NOTICE TO ALL FIRMS

Re: Addendum Number 2
IFB # C1618 – Dubinsky Center, Pomerantz Center, Business and Liberal Arts Center,
Haft Theater, & 7th Ave Façade Repairs & Cleaning

Section II. Access Platforms.

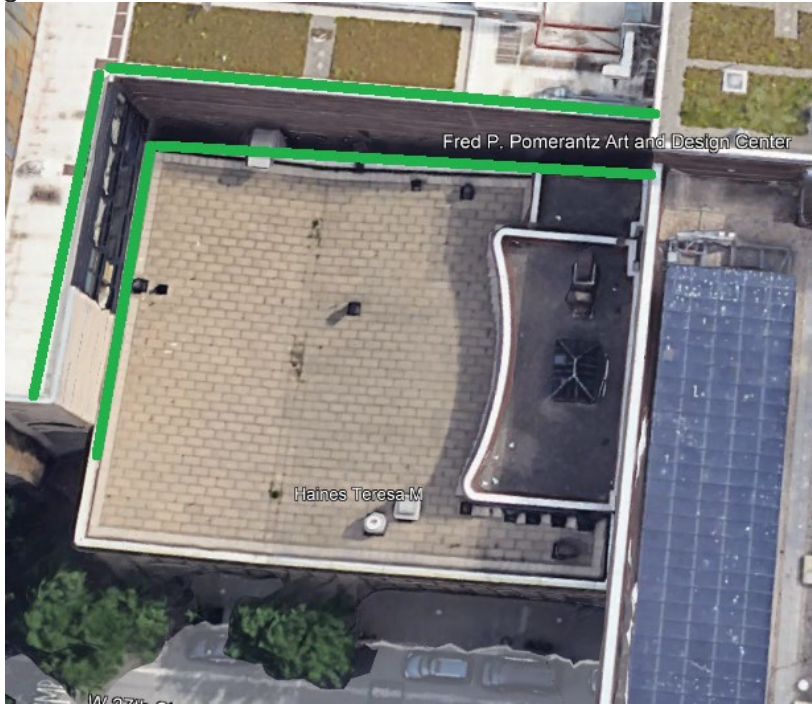
Q6. Scope I: Confirming the intent of mobilizing 100% as per bid form does not mention the north elevation.

Part 1. Install pipe scaffolding as necessary to complete the exterior repairs at the South elevation (entire) and east- and west-facing portions of the East and West elevations located directly below the 18th floor setback terrace. Provide and install code compliant Pipe Scaffolding atop Overhead Protective Bridging to the full height of the building, including setback terraces (if any), netting, stairs, outrigger protection etc. as required for

A6. Paragraph to be revised to read: @ East, West, North and South elevations of Pomerantz center.

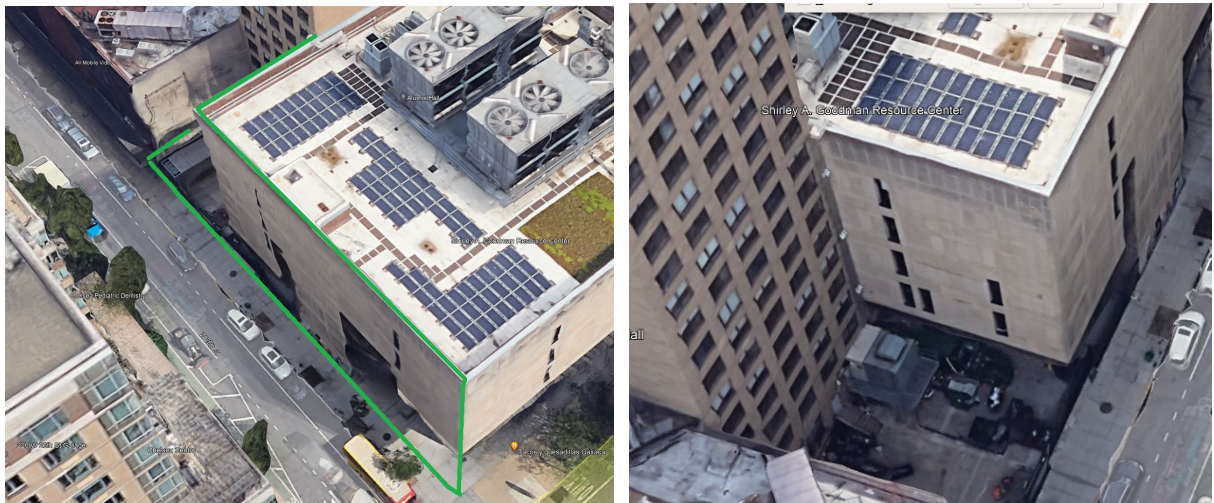
Q8. Scope II: For pricing purposes, the location of our pipe scaffold should be erected from the ground to the main roof. Please advised.

A8. Yes, only at the Pomerantz theater façade (limestone) not Feldman façade (metal panels)
